**Service Information:** **New design****Corteco No** **12019078B**

OE-Reference 04102866, 04175433

NEW DESIGN BETTER PERFORMANCES

Figure 1: old version

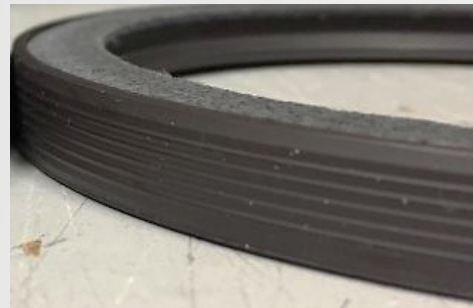
The design of the new oil seal 12019078B has changed in size, shape and materials in order to ensure a better functionality:

- the height is now of 10.2 mm, instead of 13 mm;
- the new version is in FKM rubber instead in ACM rubber, in order to ensure better performance in terms of pressure and high temperature resistance;
- the old one was partially covered by rubber and the new one is completely covered by rubber, improving the static sealing area;
- the new component has a dust lip in v-lies, defining a better protection from dirt and dust.
